Sunrail Phase 3

November 7-10, 2016

Value Engineering Study Final Report

RECOMMENDATION No. 2: Share AAF/Brightline track from the ITF to the OUC corridor

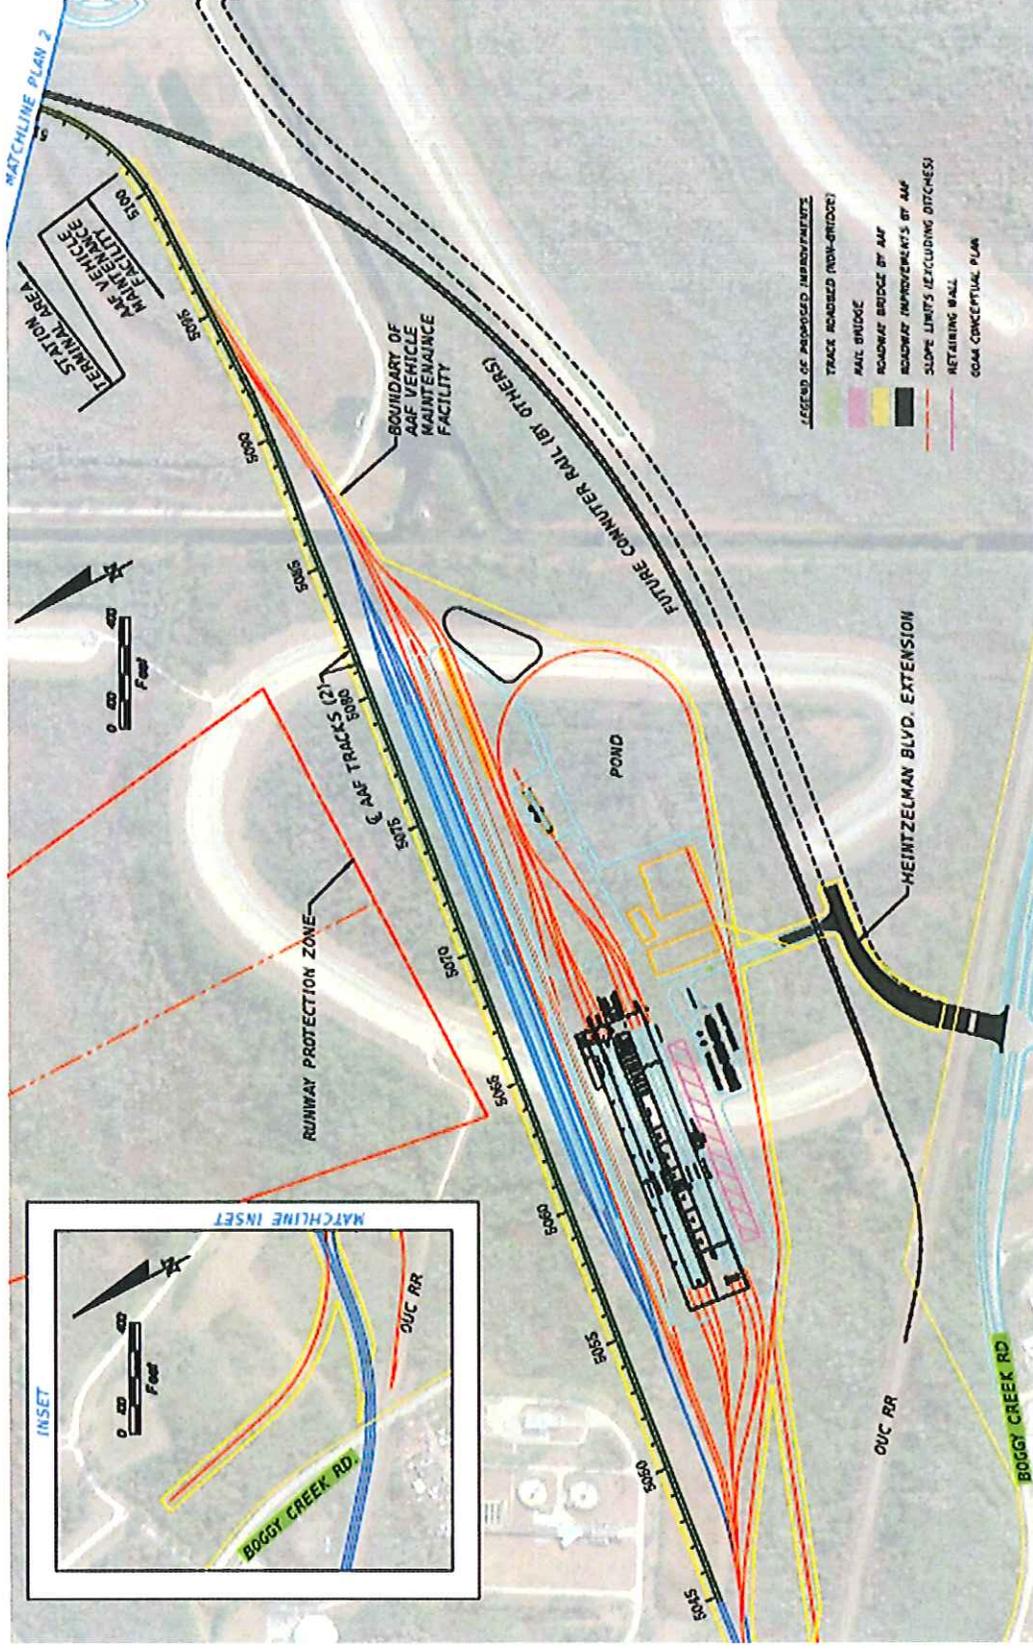
The PD&E Documents show new corridor for SunRail between Orlando International Airport ITF and the OUC (Stanton Spur) track corridor just north of E. Wetherbee Rd.

Potential Right of Way Savings	\$ 7,624,982
Potential Capital Cost Savings	\$31,247,604
	\$38,872,586

Response: *This VE Recommendation is not accepted by the PD&E Team.* Currently the construction schedule for the Brightline extension from West Palm Beach to Orlando is not defined. Significant coordination and potential MOUs including negotiations for use of Brightline tracks would be required. SunRail would be responsible for implementation of Positive Train Control and other potential operational improvements for passenger service where Brightline operations for this section of potential shared track are for only non-passenger/maintenance use.

RECOMMENDATION No. 3: Leave the existing CSX track and build a single center platform between OIA and SunRail tracks

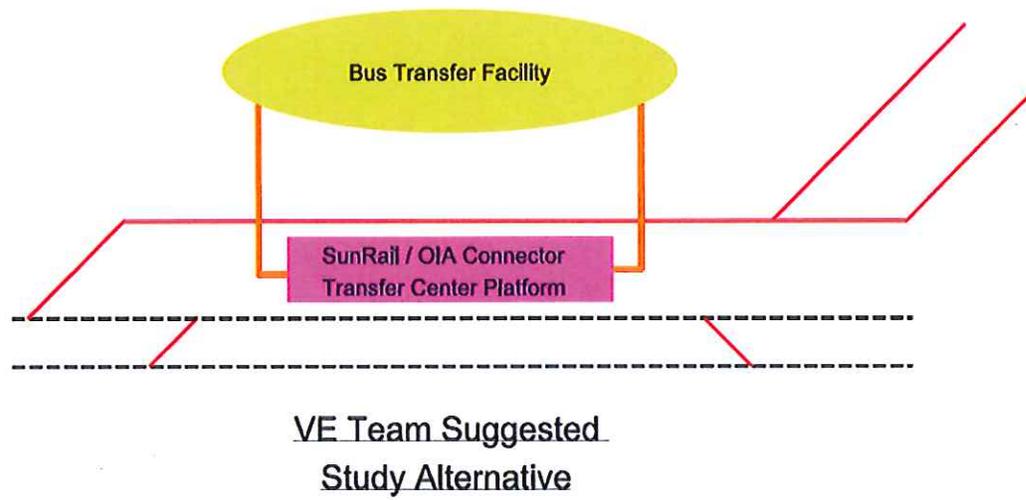
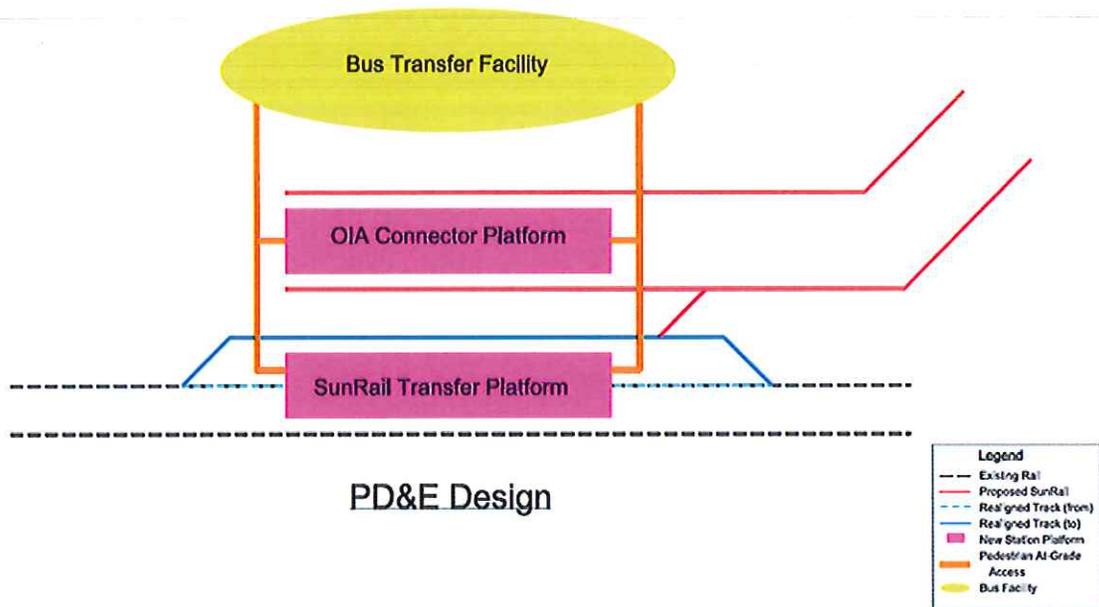
The PD&E Documents show realigning the SunRail/CSX eastern mainline track to accommodate a center platform. OIA Connector would come in on the east with two tracks and a center platform. Pedestrian grade crossing of eastern CSX track. Bus facility is east of OIA Connector tracks.

The VE team recommends eliminating realignment of SunRail/CSX mainline track, provide only a single platform to the east of the SunRail/CSX mainline. Provide single OIA Connector track east of the platform with tail track for connection to CSX Mainline (non-revenue service movement). Maintain placement of bus facility to east of OIA Connector track. Provide a turnout just south of the platform to allow the OIA Connector to utilize two tracks south of the station. Potential for tail track north of station for OIA Connector for flexibility. Add crossovers on SunRail/CSX mainline to allow access to platform from both tracks.

Response: *This VE Recommendation is not accepted by the by the PD&E Team.* Current two platform/double track design recommended through RTC analysis with 15 minute headways. Center platform utilizing mainline track on one side presents additional operational and scheduling concerns with the IOS and Phase 2 South service.

RECOMMENDATION No. 6: Shift the Approach to the ITF farther north and Increase the Profile Grade from 2.5% to 3.0%

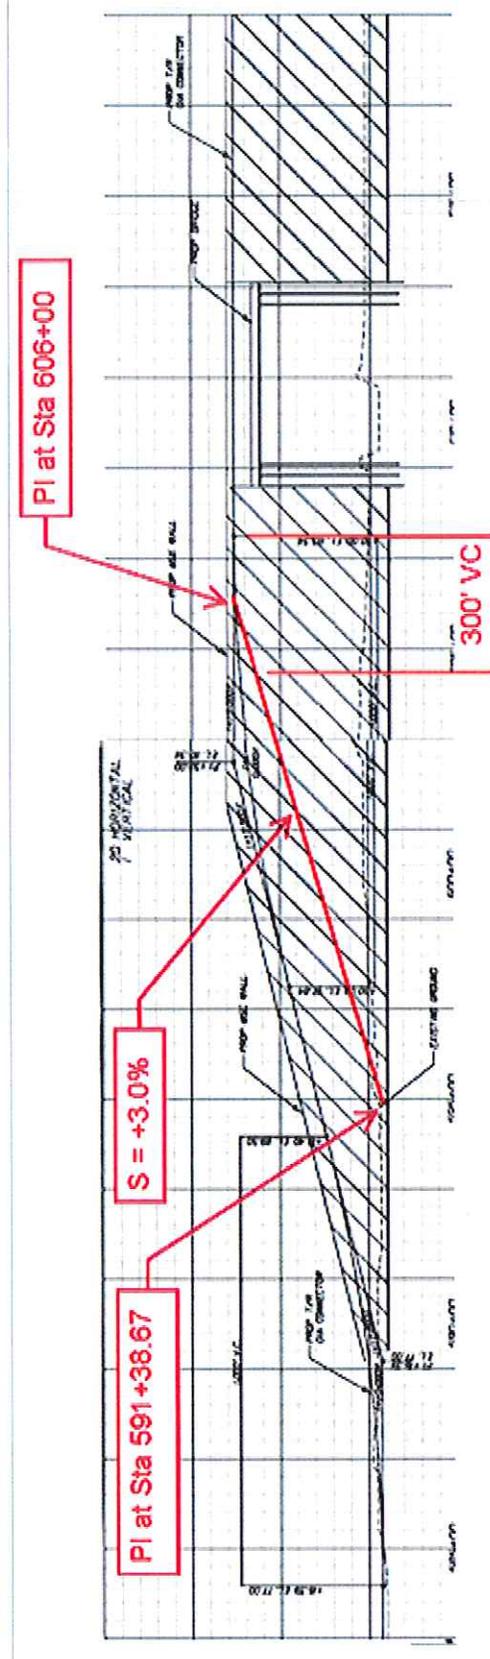
The PD&E Documents show a profile grade of 2.5% to attain the level grade of 0.00% at elevation 110.34 for connection to the ITF. The grade change is accomplished via a 1,000 ft. long vertical curve. The track alignment incline starts at approximately Station 589+00 and the guideway is on retained fill with MSE walls and a proposed 450-ft. long bridge spanning the access road and pond off of Jeff Fuqua Road.

2) Using a conservative vertical curve length of 300 ft., and holding the end of vertical curve from the PD&E drawings, located at Station 607+50, the revised point of vertical intersect would be at Station 606+00. Inclining the track profile at 3.0% from elevation 110.34 to elevation 77.00 requires a horizontal length of 1,124 ft. Therefore, the beginning of the approach would be at approximately Station 594+76.

Response: This VE Recommendation will be given further consideration by the PD&E Team. Current design of 2.5% grade was coordinated with FDOT in review of plans. Maximizing grade and minimizing vertical curve lengths to extremes are not generally desirable until the project is more defined. A higher grade may have impact to power needs, rider comfort, design of safe braking distances and bumping post at the ITF station. Potential additional costs in track maintenance due to additional forces on track due to deceleration/acceleration from stopping and starting on sloped grade in close proximity to the ITF station. A change would also require an update to the CFRC Design Criteria.

RECOMMENDATION No. 8: Build the new Transfer Station and implement Bus Rapid Transit (BRT) service along the proposed right of way to the ITF

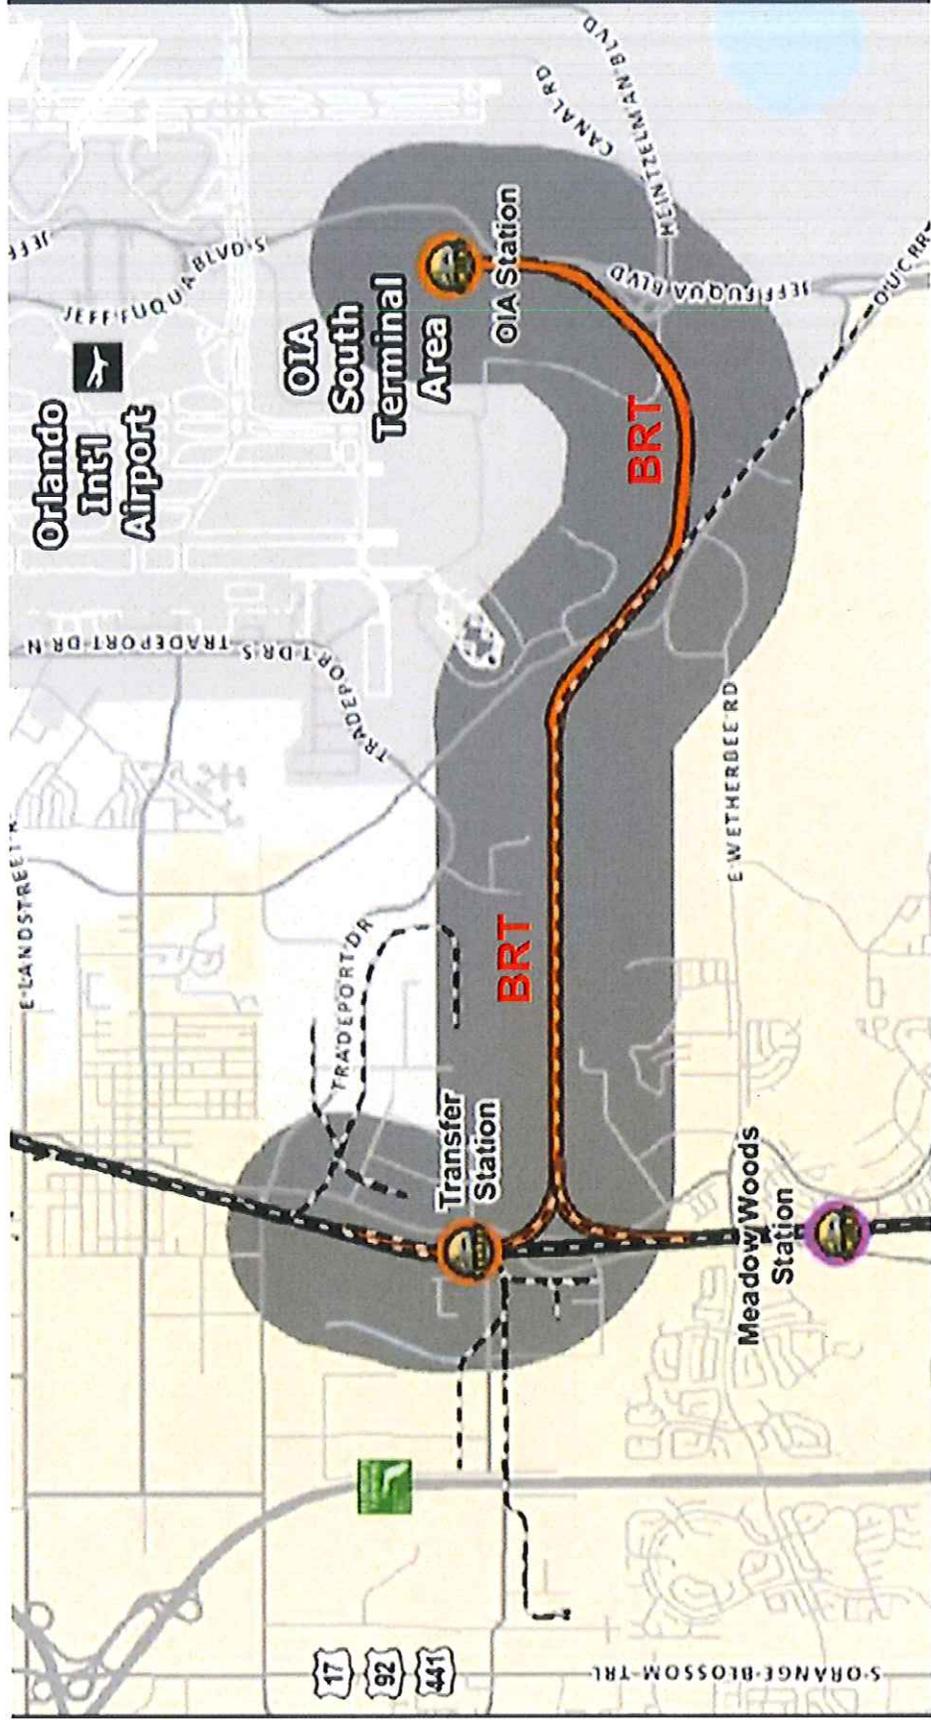
The PD&E Documents show using Heavy Rail CRT (3 diesels, 3 cab cars and 3 coaches).

Response: This VE Recommendation is not accepted by the PD&E Team. The direction provided for this study was to utilize existing SunRail technology. A BRT project would require reevaluation.

RECOMMENDATION No. 18: Shorten the bridge at Sta. 545+50 from 900 ft. to 200 ft. due to anticipated shrinking of the floodplain (by others)

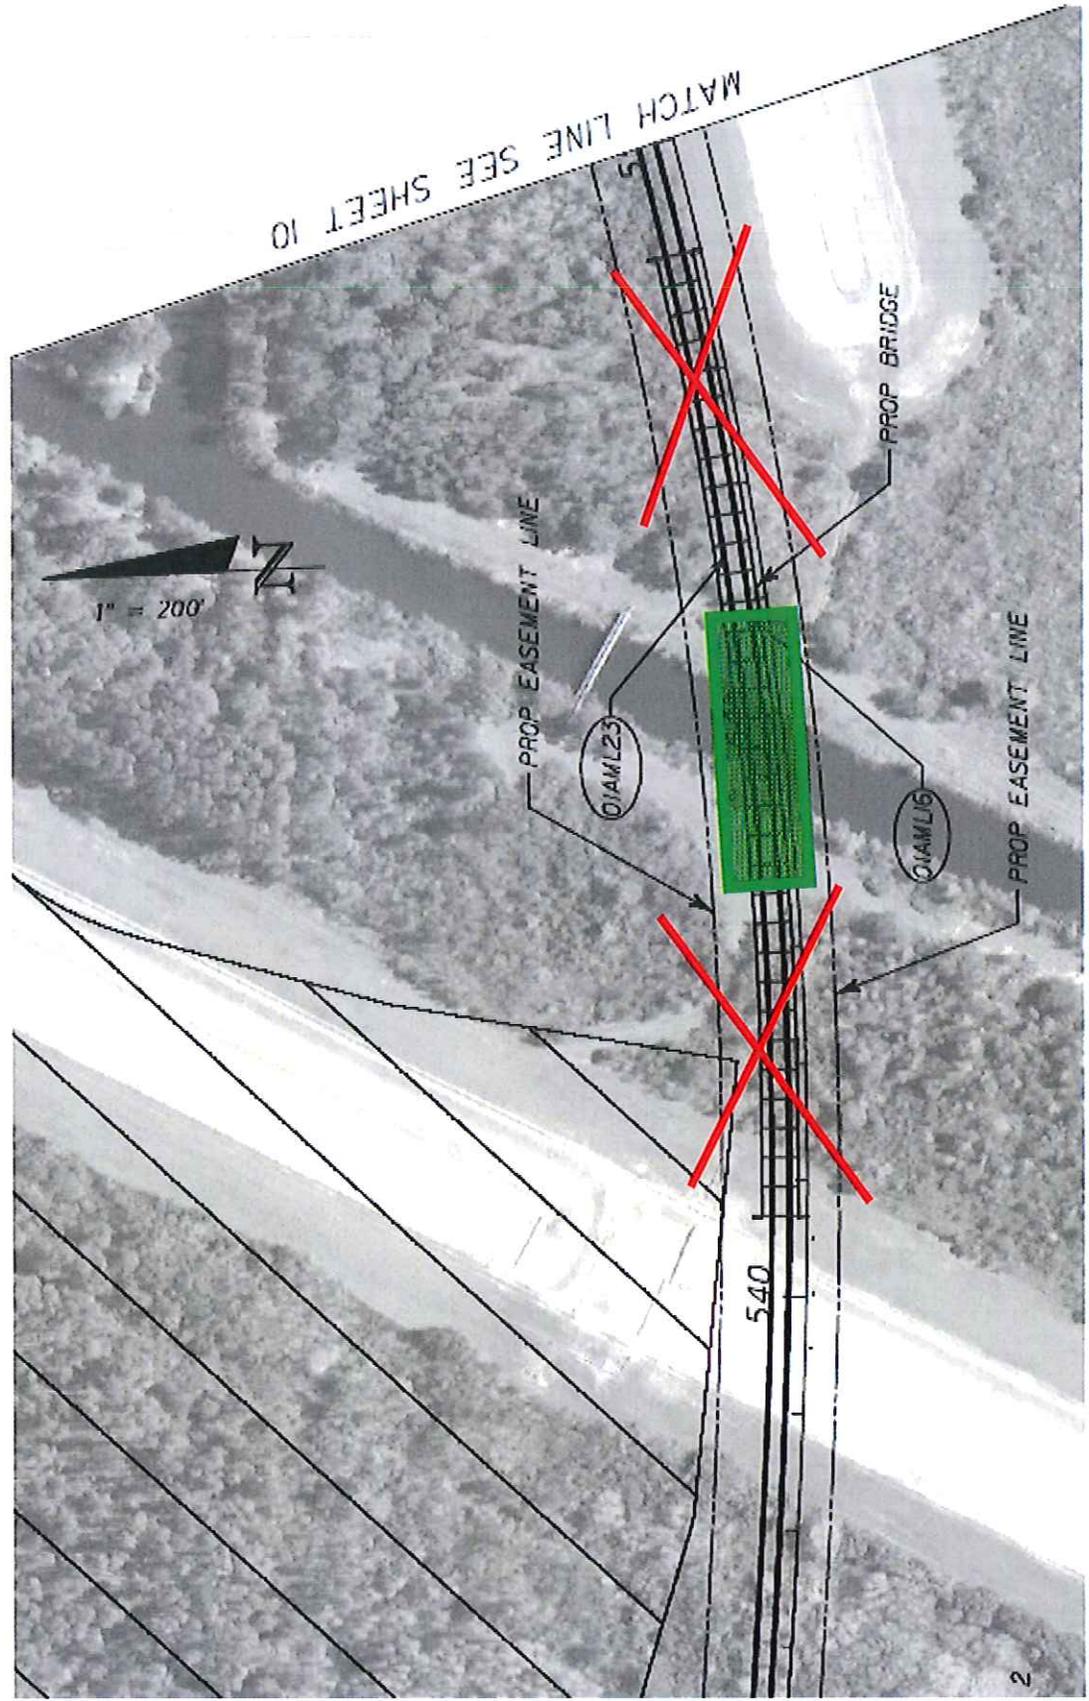
The PD&E Documents show a proposed bridge (900 ft.) spanning the current regulated floodway area at station 545+50 (approx.).

Response: *This VE Recommendation is accepted by the PD&E Team.* GOAA has stated they are in the process of updating/revising floodplain limits in conjunction with the work on the South Terminal expansion at the northern limits of the SunRail project. Continued coordination is needed to capitalize on opportunities to manage water resources in this area and shorten the floodway crossing.

RECOMMENDATION No. 25: Realign Heintzelman Canal (by others) to eliminate the RR Bridge

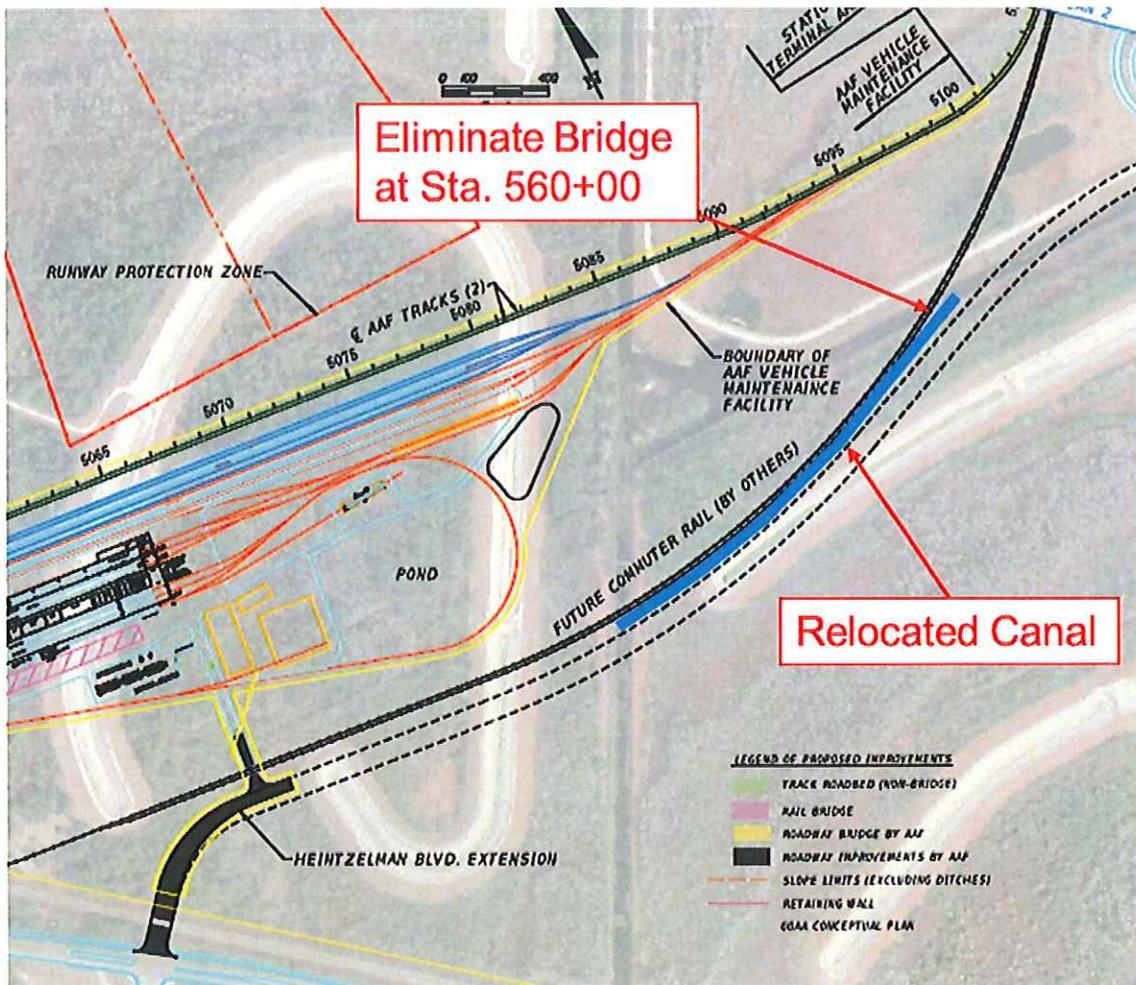
The PD&E Documents show a proposed bridge (200 ft.) spanning the Heintzelman canal at station 560+00.

AAF is conceptually planning to build a maintenance facility within the project limits, which includes a connection between Canal Road and Wetherbee Road. Consequently, a realignment of the Heintzelman canal is anticipated to maintain existing hydraulic patterns. As a result the bridge at station 560+00 can be eliminated. Moreover, this would reduce the hydraulic load upstream of the bridge at station 545+00 as well as the floodplain area described in Recommendation No.18.

Response: *This VE Recommendation is accepted by the PD&E Team.* GOAA has stated they are in the process of updating/revising floodplain limits in conjunction with the work on the South Terminal expansion at the northern limits of the SunRail project. Continued coordination is needed to capitalize on opportunities to manage water resources in this area with the proposed Heintzelman Road extension (by others), that would remove the need for a bridge crossing of the proposed road and the SunRail bridge crossing.

RECOMMENDATION No. 26: Revisit RTC runs and move double track section to center of alignment.

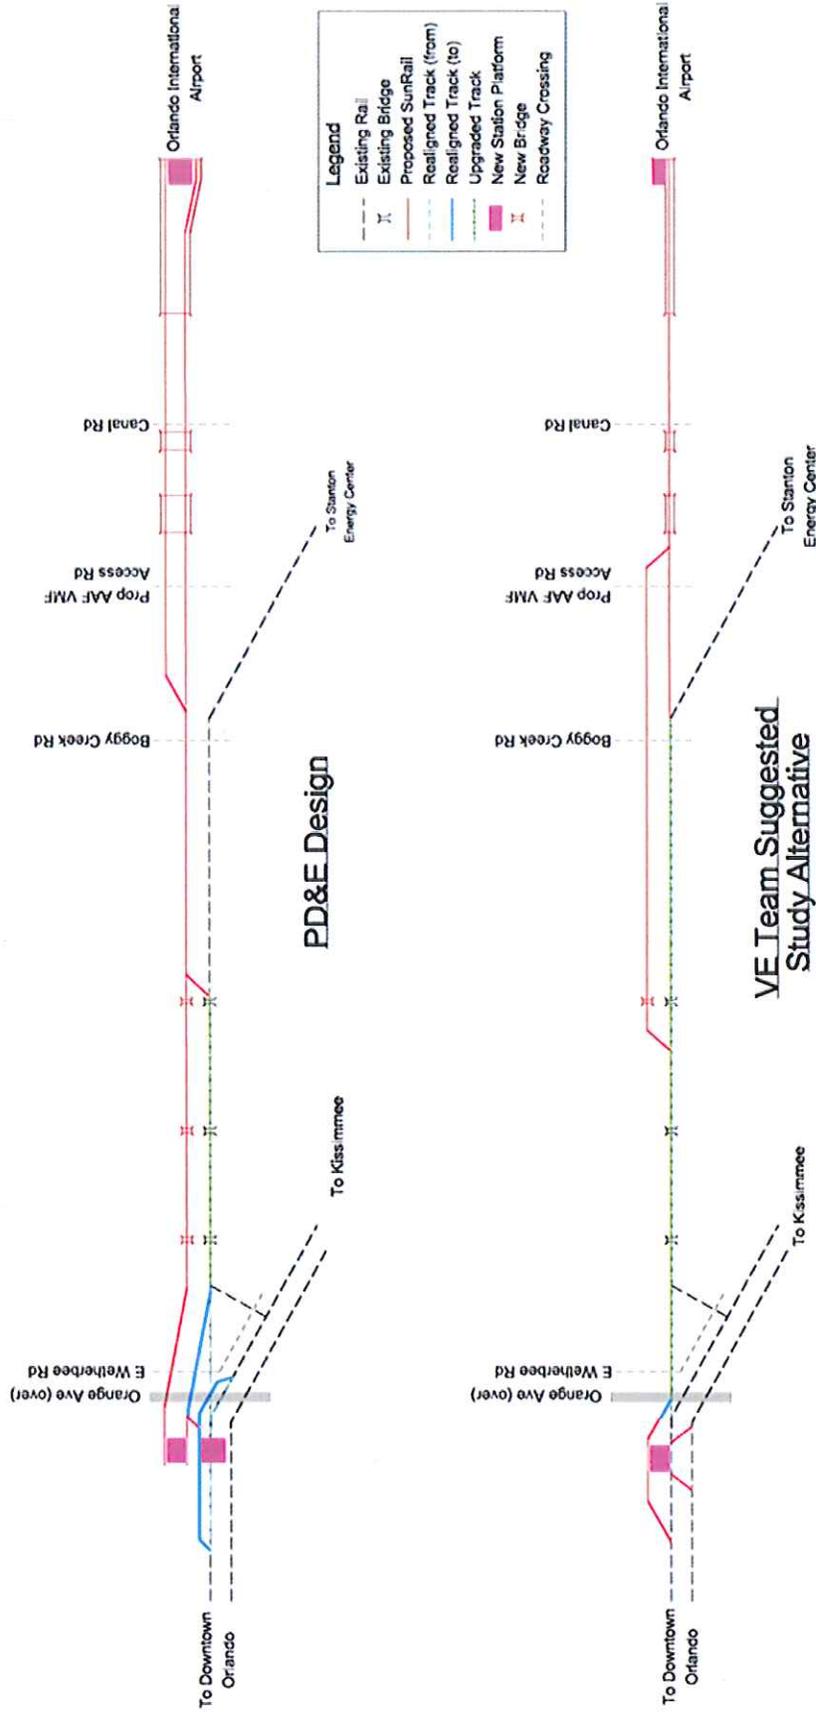
The PD&E Documents show the RTC Runs indicate a need for double tracking at the east and west ends of the alignment (at the stations) resulting in 4.25 miles of the 5.35 mile corridor being double tracked.

Response: *This VE Recommendation is not accepted by the PD&E Team.* Additional RTC modeling runs reducing the length of double track and providing the passing track in the middle of the project indicate that four trains would be required to meet 15 minute headways. The current location of new track and shared track has been coordinated with OUC.
